**CITY OF RICHMOND**  
URBAN DEVELOPMENT DIVISION

**REPORT TO COMMITTEE**

**TO:** Planning Committee  
**FROM:** Joe Erceg  
Manager, Development Applications  
**DATE:** April 3, 2000  
**FILE:** RZ 99-172844  
**RE:** **Application by Suncor Development Corporation for Rezoning at 4771 and 4791 Williams Road from Single-Family Housing District, Subdivision Area E (R1/E) and a portion of 9711 Geal Road from Assembly District (ASY) to Comprehensive Development District (CD/114)**

2. 2000/07 Beth Tikvah Townhouse Project DP 00-085462  
*Gomberoff Bell Lyon Group of Architects Inc.*  
Geal/Williams Roads  
(formal)

WILLIAMS ROAD  
SITE PLAN

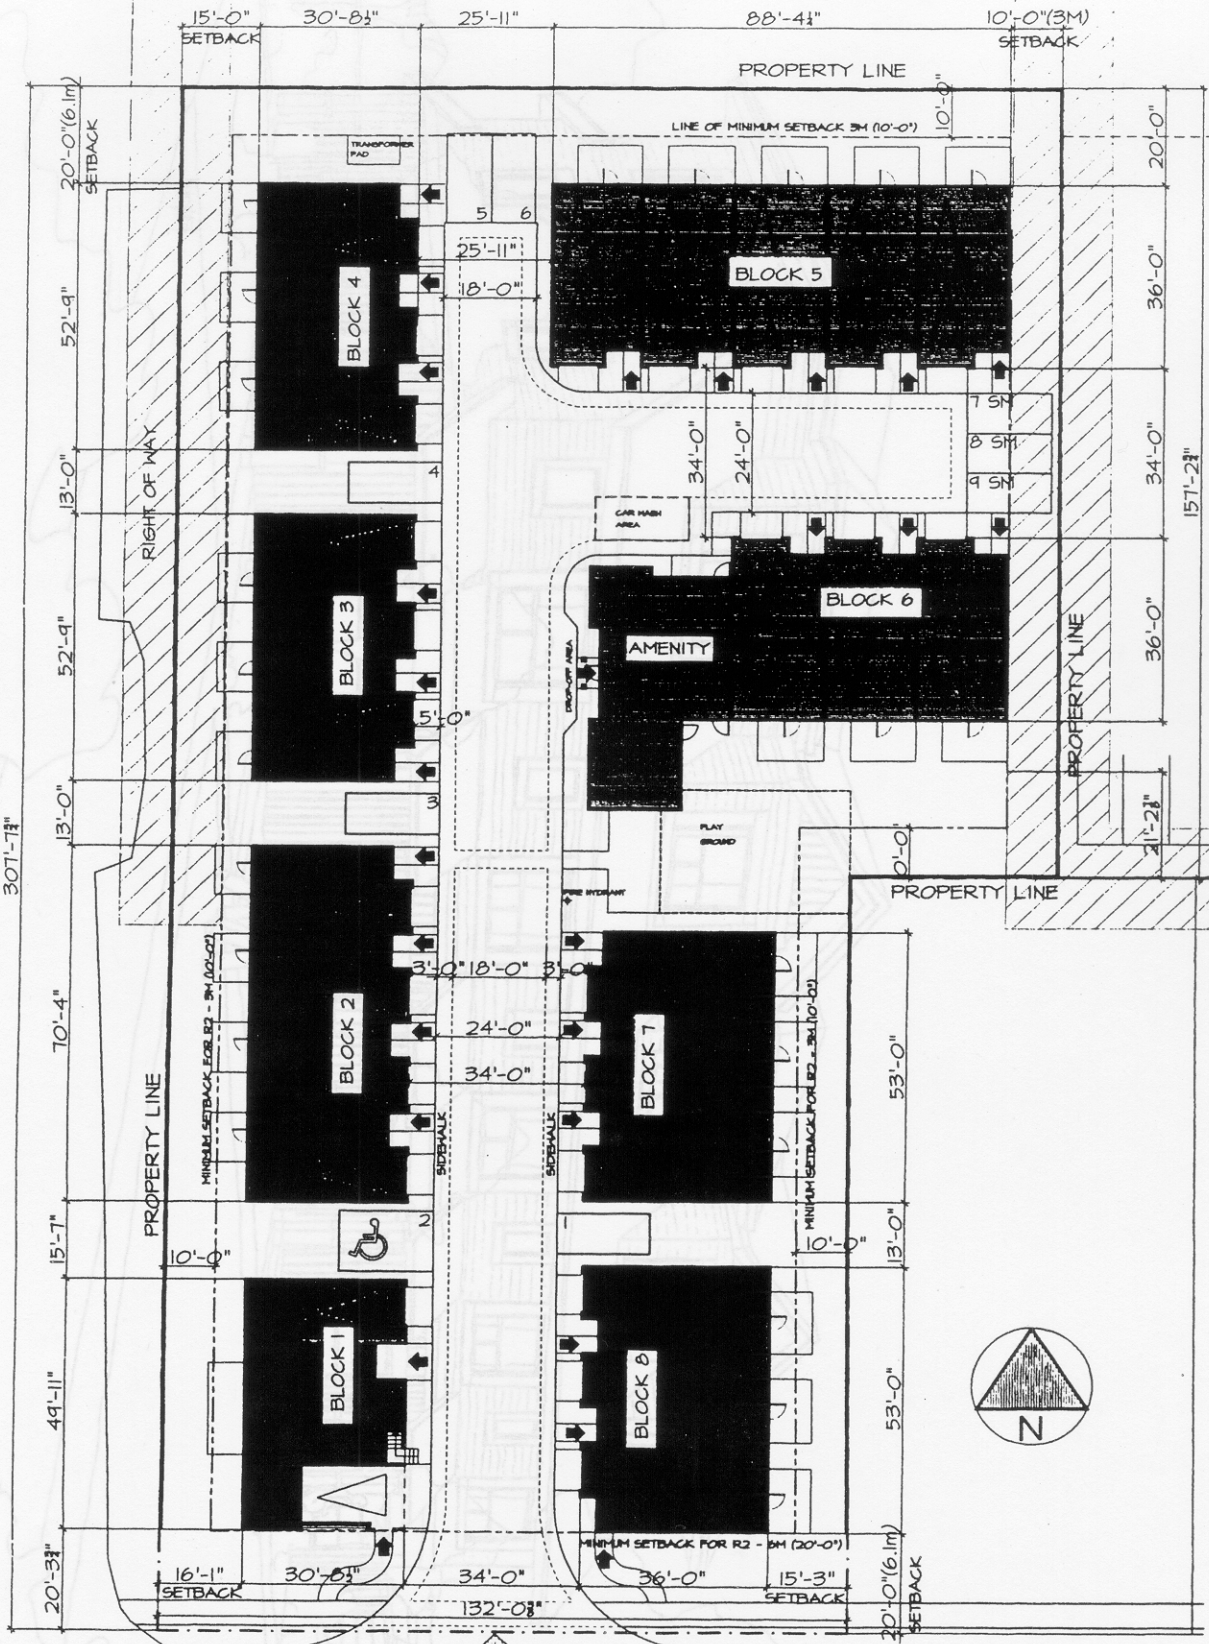
- g) The applicant is asked to investigate the provision of tandem parking vis-à-vis its impact on the FAR.
- h) Wherever possible, the applicant is asked to look into making the development less compact. For example, an attempt should be made to provide space between the amenity building and Blocks 6 & 7.

- a) There is a need to revisit the issue of the driveway width (at 34') in order to accommodate trees along this driveway.
- b) Overall, there is a need to review the landscape plan. It appears that there is more planting in the smaller yards and less planting in yards

There are a number of neighbourhood concerns with the subject proposal mainly regarding parking, density and height of the townhomes. Parking concerns were addressed by increasing the parking ratio from 1.2 spaces per unit, which was originally shown at the Public Information Meeting, to 1.9 spaces per unit. In terms of density, while the actual amount of built form remains the same, the site was opened up by increasing distances between buildings and providing a larger central open space area.

- i) The number of parking to be provided has been increased to 49 (from an original 32). Tandem parking in 14 of the 26 units has allowed the project to increase its parking count.

Attachment 4

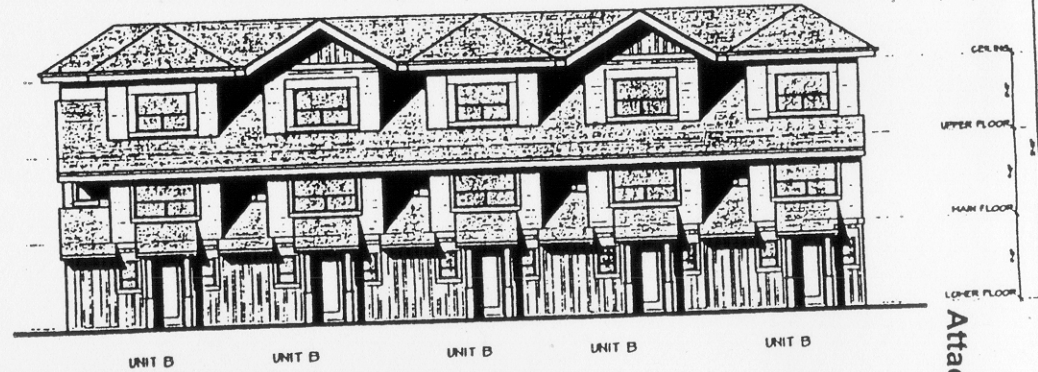
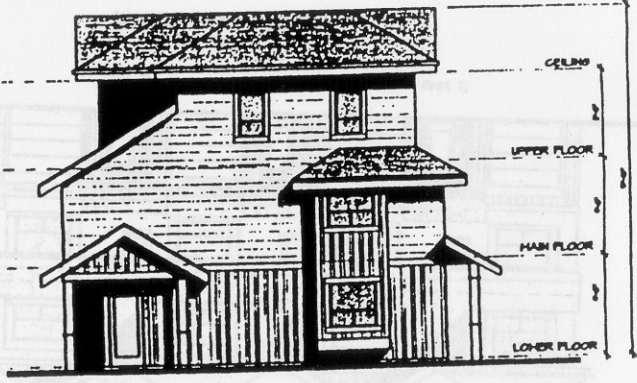
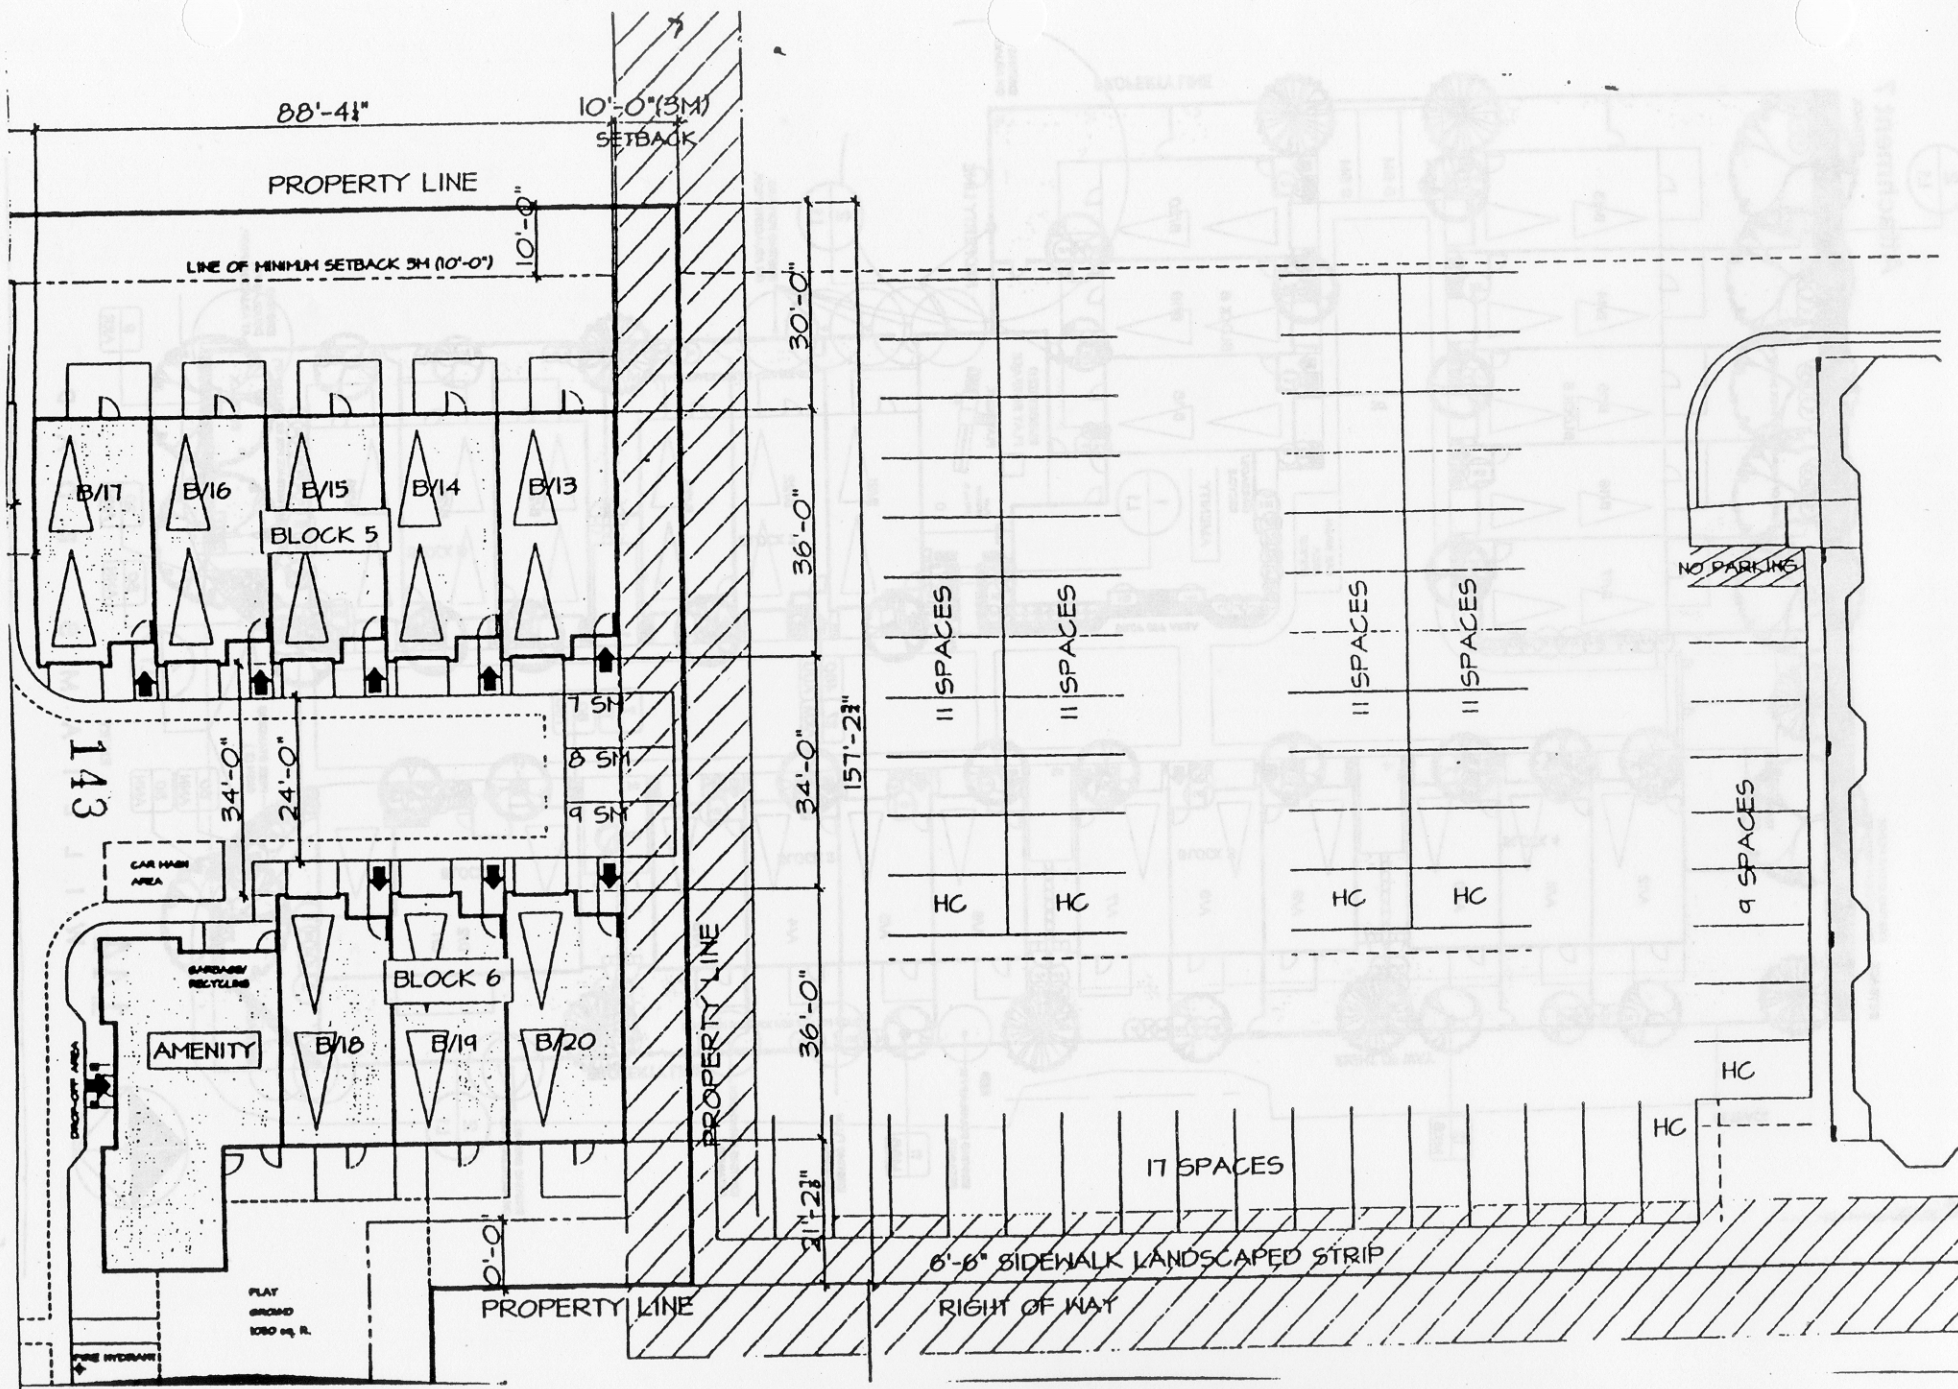
- enhance the Williams Road elevation;
- change the posts supporting doorway overhangs in the private rear yards so they don't appear flimsy;
- change the location of the garbage area;
- break the intermediate roof line along the fronts of the buildings;
- look into making the development less compact – provide more spaces between buildings;
- mitigate edge conditions to ensure liveability; and
- look at the driveway width in terms of providing trees.

- ◆ There appears to be a need to enhance the Williams Road elevation as this is the public face to the project site;
- ◆ In addition, it appears that the applicant needs to look at reducing the impact of the project being a three-storey development in light of the fact that the most of the neighbouring structures are two-storey in height. Building heights could perhaps be lowered at the ends of the buildings. This concern has been expressed by residents from the neighbourhood.

- a) The Williams Road elevation requires further enhancement, particularly the treatment of the building component to the east. In this regard, the applicant is asked to look into the possibility of bringing the intermediate roof feature around the front of the building.

- the landscape plan was altered to address concerns about the visibility of the access for the church site, which is located directly west of the subject property;
- the Williams Road elevation was enhanced by wrapping around a secondary roof element and enhancing a window feature;
- after clarification with the fire department, street trees were placed on both sides of the internal driveway; and
- in response to concerns by the neighbourhood residents about a site contact, the GVHC has stated that a 24 hour-a-day emergency number will be posted on the amenity room/office door which will have GVHC staff on call to deal with project concerns.

- ◆ The Williams Road elevation has been enhanced. Front entries to the C1 and B 26 units will be along the street.
- c) In terms of site context: to the north is an existing single-family subdivision; to the south, across Williams Road is an existing single-family subdivision; to the east is the parking of the synagogue and a single-family lot containing a transition home; and immediately to the west is the parking lot of St. Joseph's Church.
